Site Accessibility Evaluation

Black Forest Regional Park

Accessibility Evaluation

Inspection Date: 08/09/2017

Finding: 3

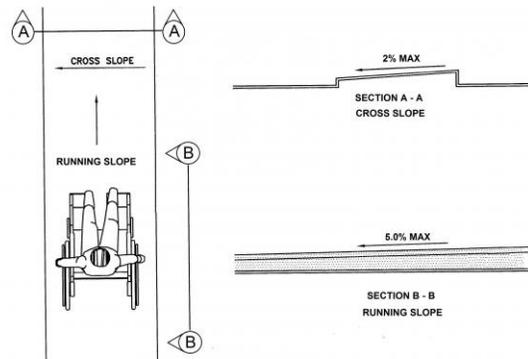
The accessible route contains running slopes greater than 5 percent and cross slopes greater than 2 percent across the width of the walk and has not been constructed as a ramp (i.e. handrails, wheel guides, etc.).

Running slope ranged from 6.6% to 7.3% //
Cross slope ranged from 2.1% 3.0%

Install handrails on both sides that comply with 505 due to the running slope exceeding the maximum slope allowed (1:20 or 5.0%).

Add level landings at the top and bottom of the ramp run and every 30 feet in between complying with 405.6

Finding: 4

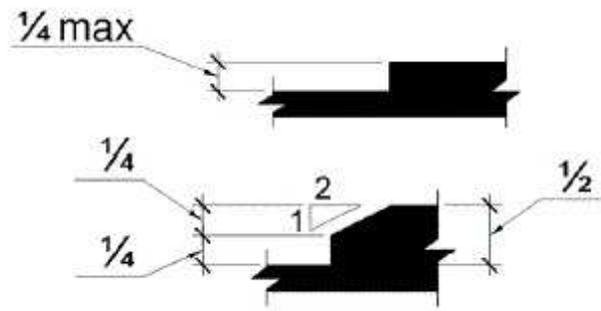
There is a change in level greater than 1/4 inch.

3/4 inch upheaval

Edge/bevel treatment on access route throughout due to changes in level exceeding the 1/4 in vertical maximum and 1/2 in horizontal separation maximum.

Finding: 6

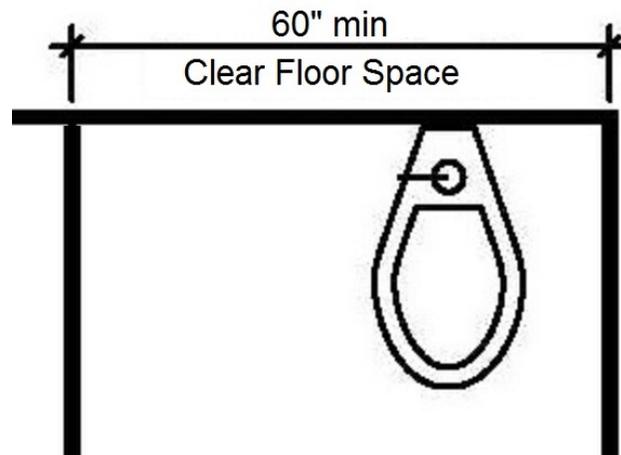
The toilet compartment is not wide enough.

**Toilet closet measured
36 inches wide.**

Major remodel/construction will be required to meet current ADA Standards.

Finding: 7

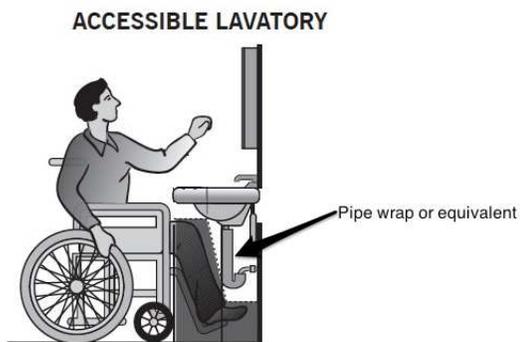
The water and drain pipes under the lavatory are not adequately insulated.

Drain pipes not insulated

Insulate drain pipes underneath lavatory.

Finding: 8

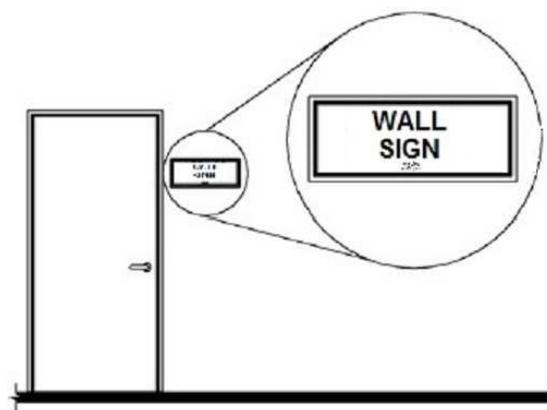
The tactile sign is incorrectly located.

Tactile sign mounted directly on door.

Move sign to left/latch side of door 48 inches minimum above finish floor or ground surface measured from the lowest tactile character or 60 inches maximum from the highest tactile character.

Finding: 9

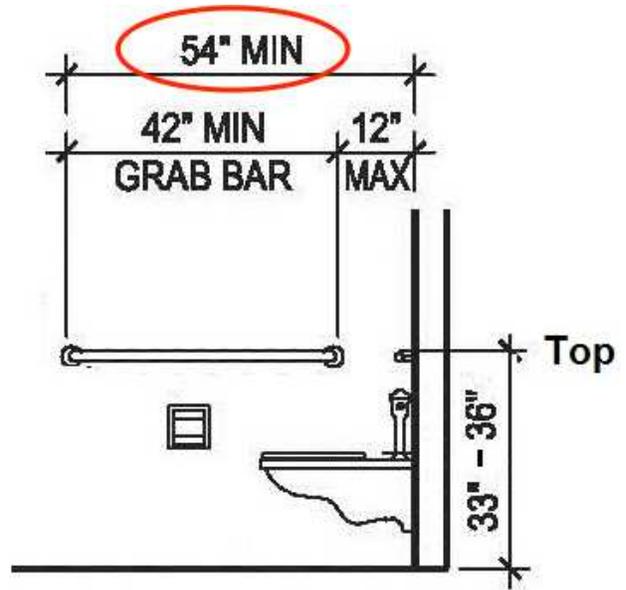
The side grab bar does not extend far enough from the rear wall.

Side grab bar does not extend the 54 inches required per ADA.

Re-position side grab bar an additional 1.75 inches away from rear wall to meet the 54 inch minimum required per ADAS.

Finding: 10

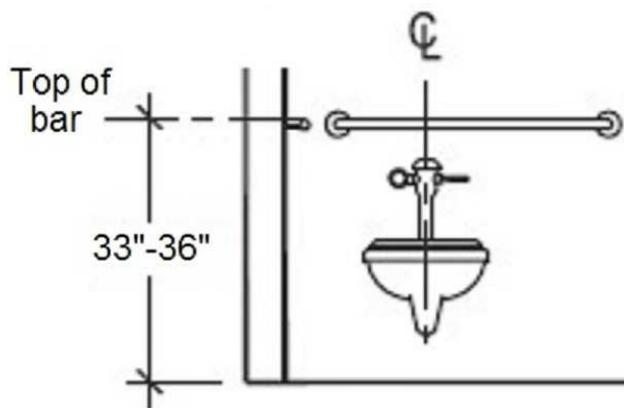
The rear grab bar is too high.

Measures 37 inches to the top of the gripping surface.

Remove and re-position 1 inch lower to comply with ADAS.

Finding: 11

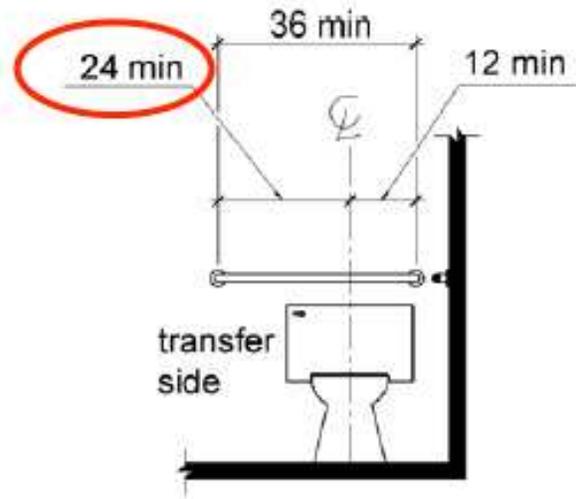
The rear grab bar does not extend adequately past the toilet on the wide side.

Width of toilet compartment does not allow for compliance

Extend width of toilet compartment and re-position rear grab bar to meet ADAS.

Finding: 12

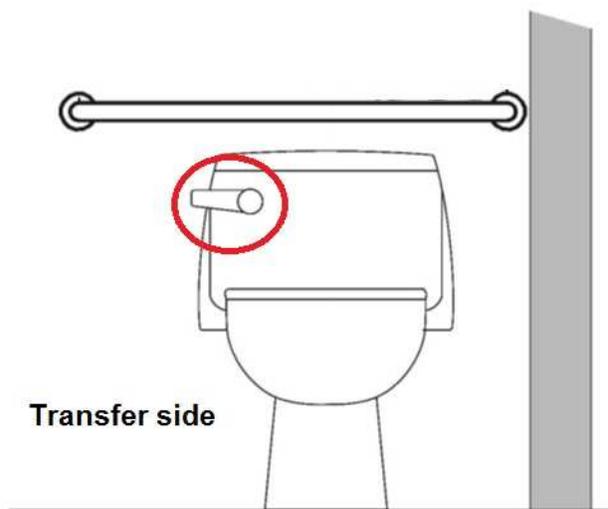
The flush handle is located on the wrong side of the toilet.

Flush handle not on transfer side of water closet

Extend width of toilet compartment and ensure flush handle is on the open side of the water close.

Finding: 13

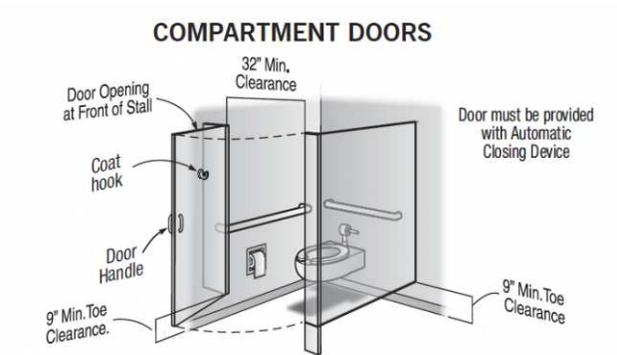
The compartment door does not have an unobstructed clear opening width of 32 inches.

Door opening width is
29 1/2 inches.

Upon reconstruction and/or alteration extend water closet door width to 32 inches minimum per 2010 ADAS.

Finding: 14

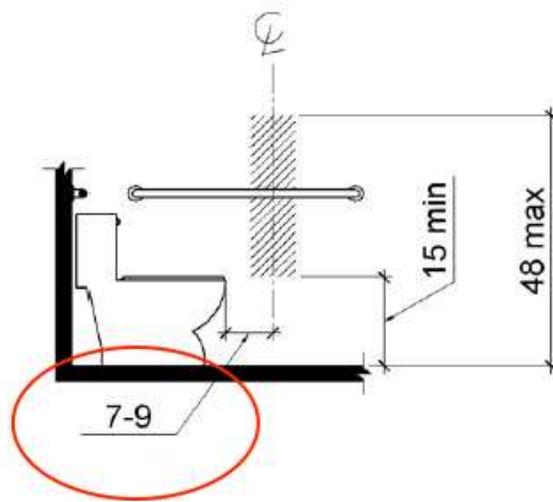
The toilet paper dispenser does not allow a continuous flow.

Does not allow continuous flow of toilet paper.

Replace dispenser with one that will allow continuous flow.

Finding: 15

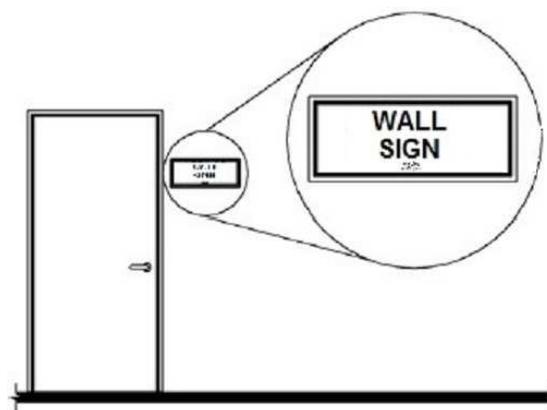
The tactile sign is incorrectly located.

Tactile sign mounted directly on door.

Move sign to left/latch side of door 48 inches minimum above finish floor or ground surface measured from the lowest tactile character or 60 inches maximum from the highest tactile character.

Finding: 16

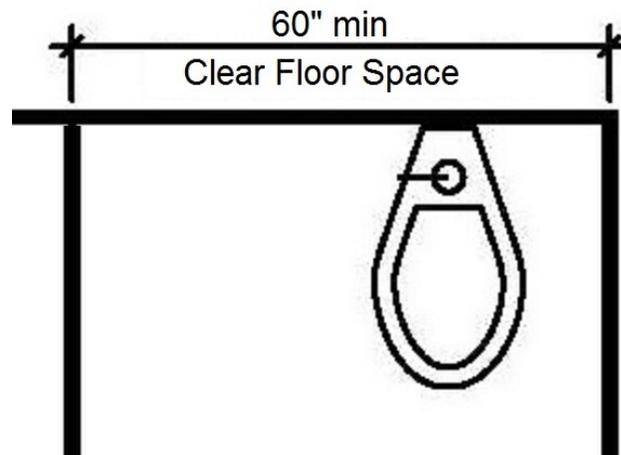
The toilet compartment is not wide enough.

Toilet closet measured
37 inches wide.

Major remodel/construction will be required to meet current ADA Standards.

Finding: 17

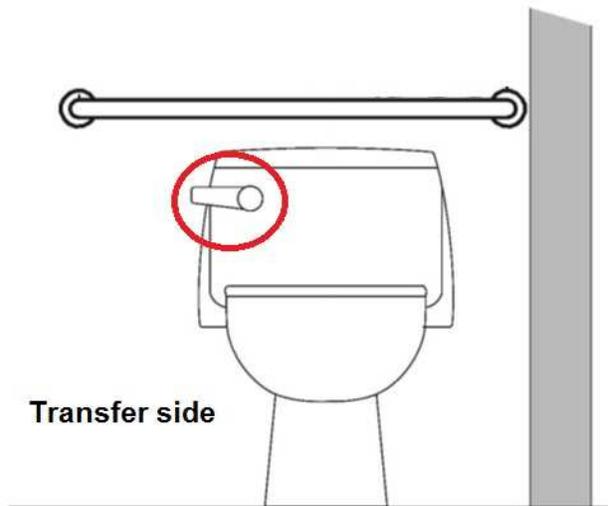
The flush handle is located on the wrong side of the toilet.

Flush handle not on transfer side of water closet.

Extend width of toilet compartment and ensure flush handle is on the open side of the water close.

Finding: 18

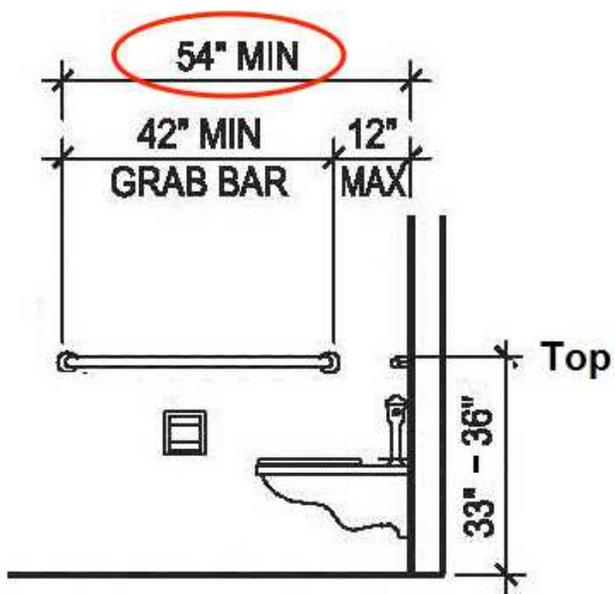
The side grab bar does not extend far enough from the rear wall.

Side grab bar does not extend the 54 inches required per ADA.

Re-position side grab bar an additional 1.75 inches away from rear wall to meet the 54 inch minimum required per ADAS.

Finding: 19

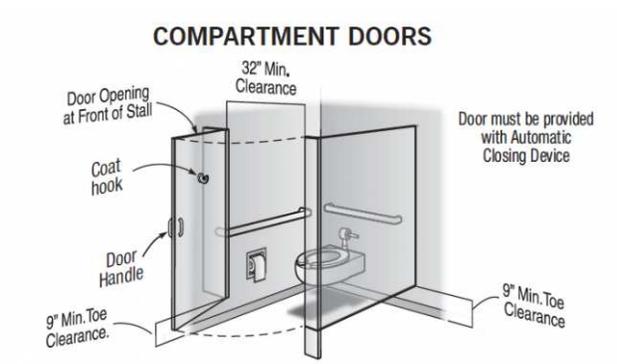
The compartment door does not have an unobstructed clear opening width of 32 inches.

Door opening width is
29 1/2 inches.

Upon reconstruction and/or alteration extend water closet door width to 32 inches minimum per 2010 ADAS.

Finding: 20

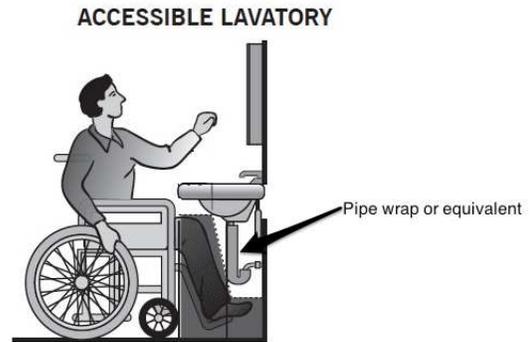
The water and drain pipes under the lavatory are not adequately insulated.

Drain pipes not insulated

Insulate drain pipes underneath lavatory.

Finding: 21

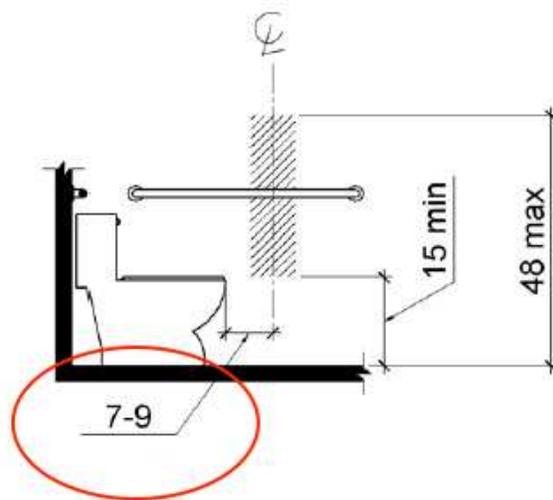
The toilet paper dispenser does not allow a continuous flow.

Does not allow continuous flow of toilet paper

Replace dispenser with one that will allow continuous flow.
